CORPORATE LAKES 3RD

AN ADDITION TO WICHITA, SEDGWICK COUNTY, KANSAS

Re: S/D 98-49-- One-Step Final Plat of CORPORATE LAKES 3RD ADDITION

Re: S/D 98-49 -- Final Plat of CORPORATE LAKES 3RD ADDITION

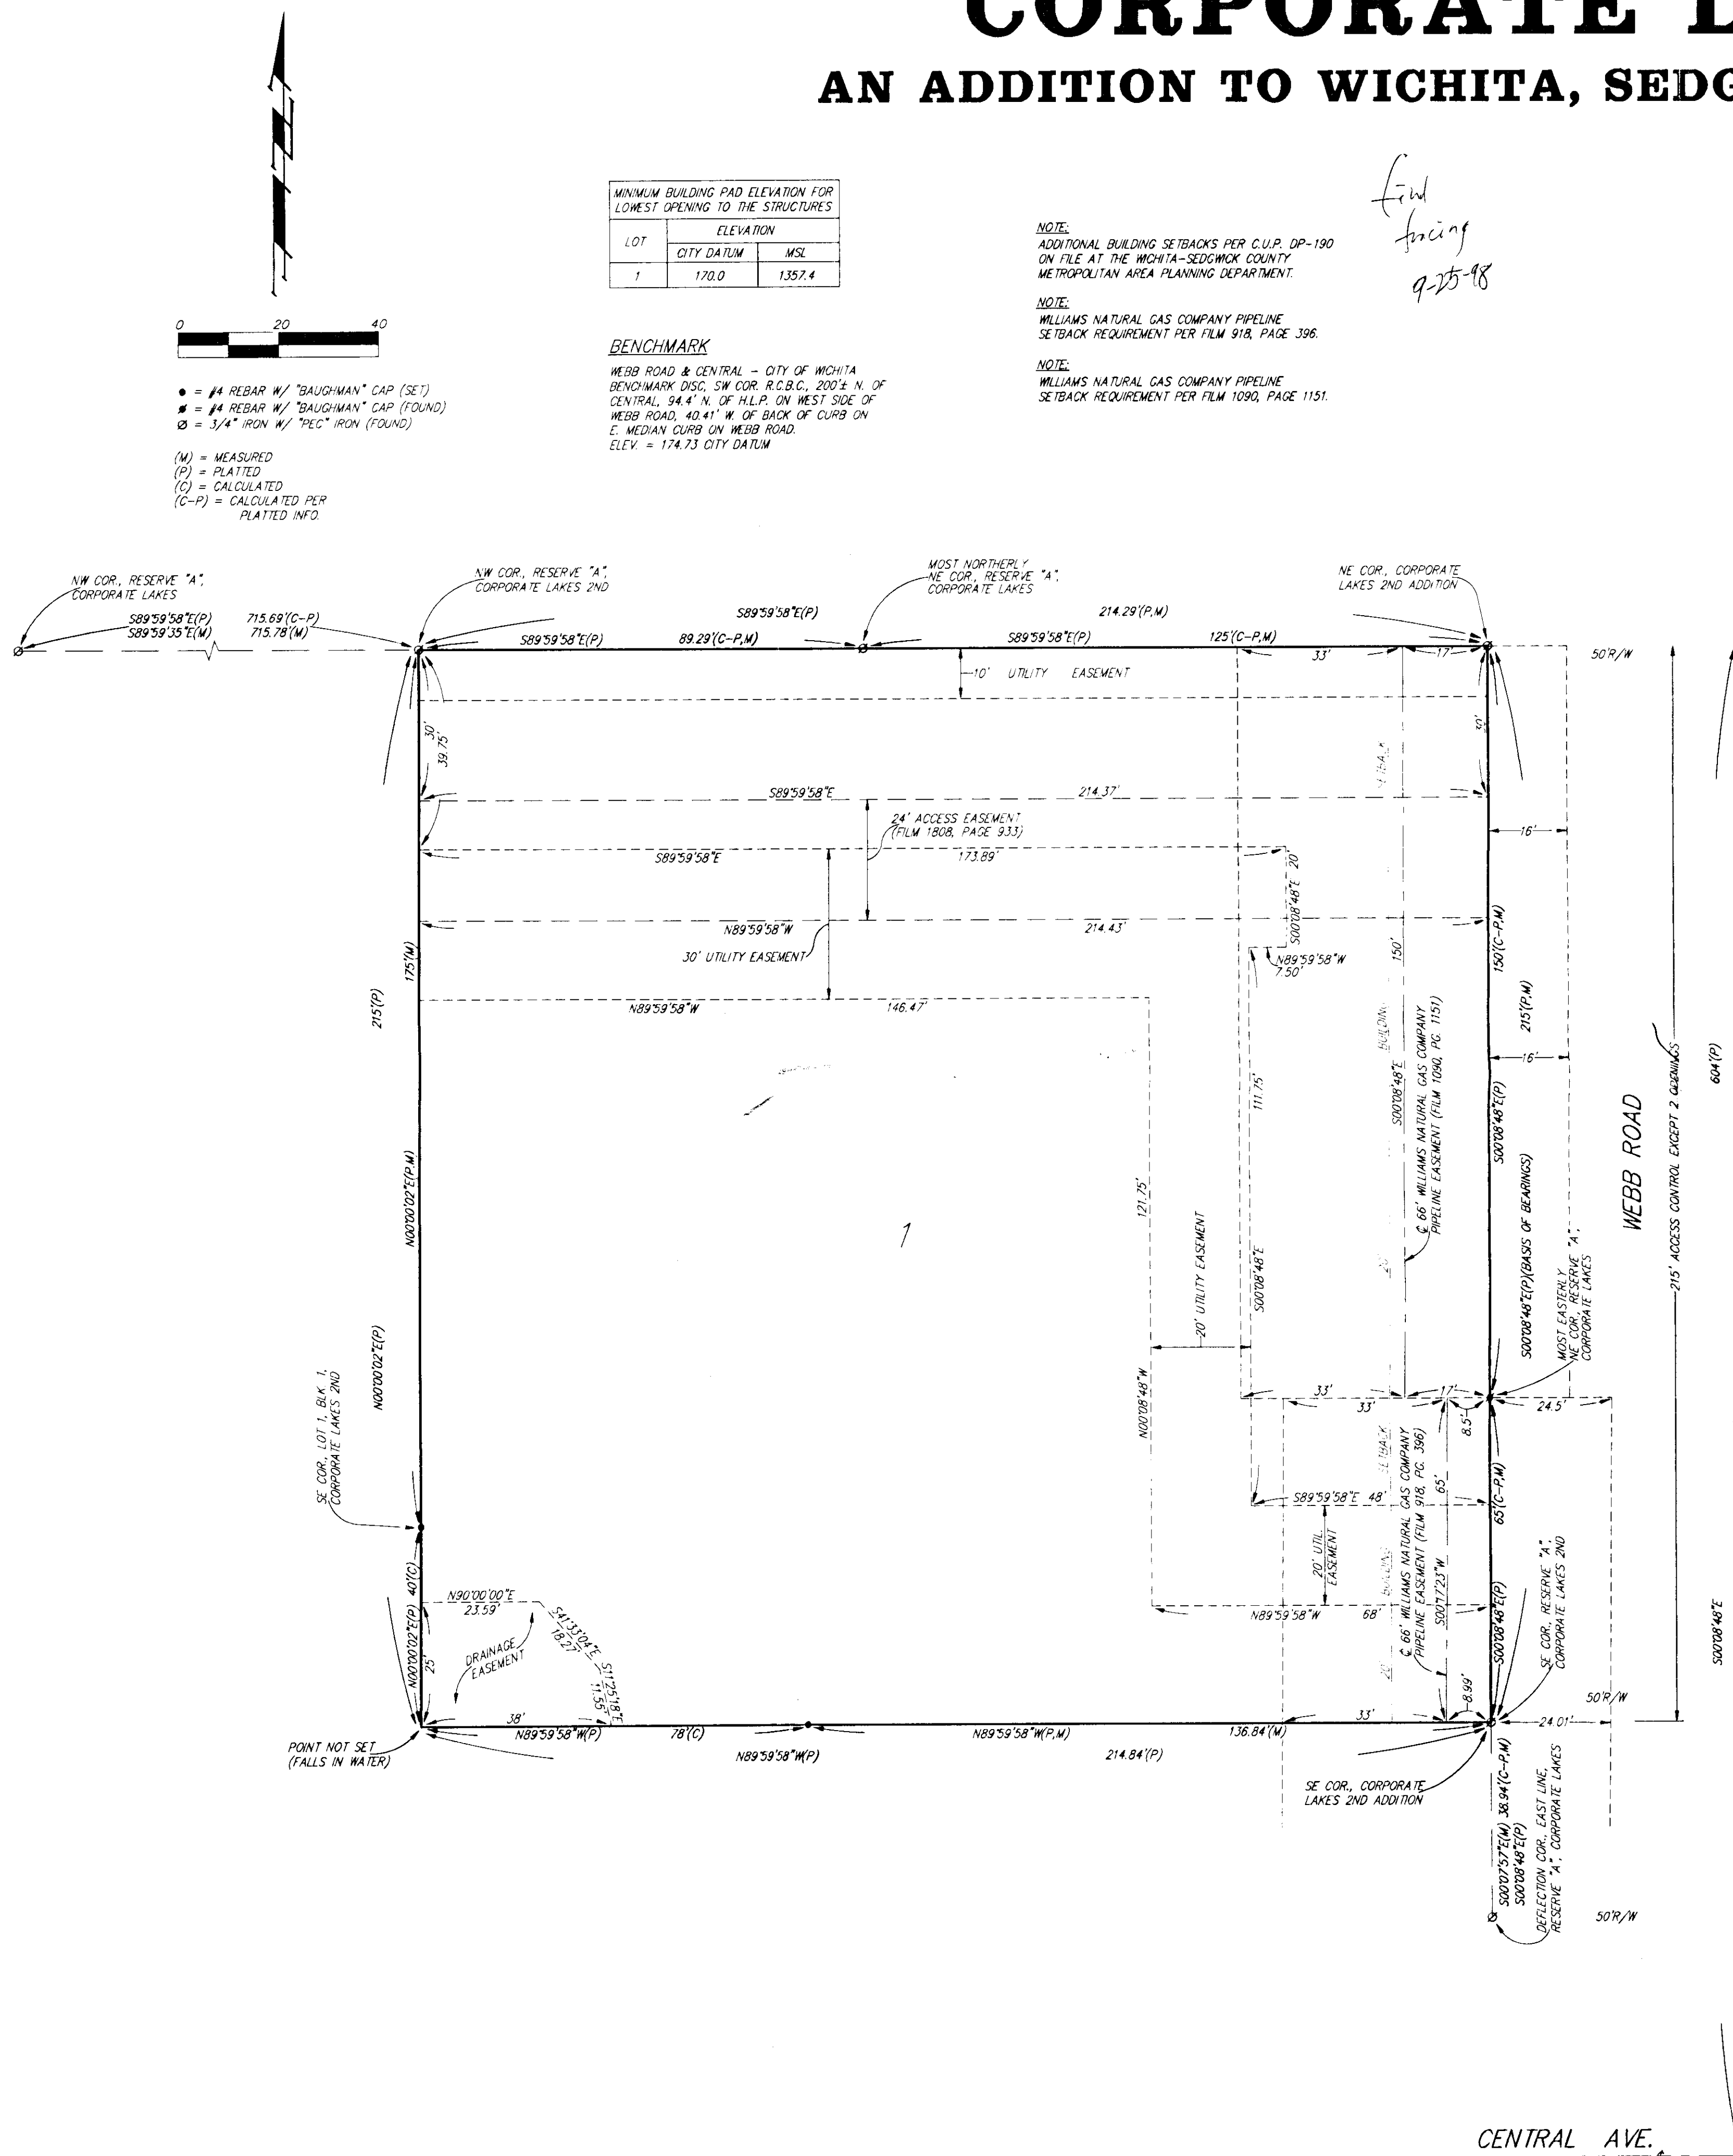
- C. City Engineering needs to comment on the status of the applicant's drainage plan.
- D. Traffic Engineering needs to comment on the proposed access controls. The plat depicts two openings along Webb Road. The associated CUP - which denotes one access opening along this portion of the site - will require an adjustment to permit two openings for this site along Webb Road. On the final plat tracing, the platlor's text shall reference access control. Traffic Engineering has approved the two openings subject to reaching an agreement with the Applicant regarding Item L before approval by the MAPC.

- G. The applicant's agent shall determine any setback requirements for the pipelines by researching the text of the pipeline agreements. If a setback from the pipeline easements is

provided for in the pipeline easement agreements, it shall be indicated on the face of the plat.

- I. The final plat tracing shall reference a tie point to a section corner along with distance to this plat.
- J. On the final plat tracing, the MAPC Chairman should be revised to read, "Richard E. Lopez".

- K. Building setback lines were established with the CUP and the previous plat. This plat proposes to reduce the building line along Webb Road from 60 feet to 20 feet. If this reduction is granted with the approval of this plat, an adjustment to the CUP will be approved.

- L. Traffic Engineering needs to comment on the need for any improvements to Webb Road. **A northbound left-turn lane shall be constructed along Webb Road.**

- M. The name of the Addition referenced in the surveyors signature block needs to read, "Corporate Lakes 3rd".
- N. The applicant shall install or guarantee the installation of all utilities and facilities which are applicable and described in Article 8 of the MAPC Subdivision Regulations. (Water service and fire hydrants required by Article 8 for fire protection shall be as per the direction and approval of the Chief of the Fire Department.)
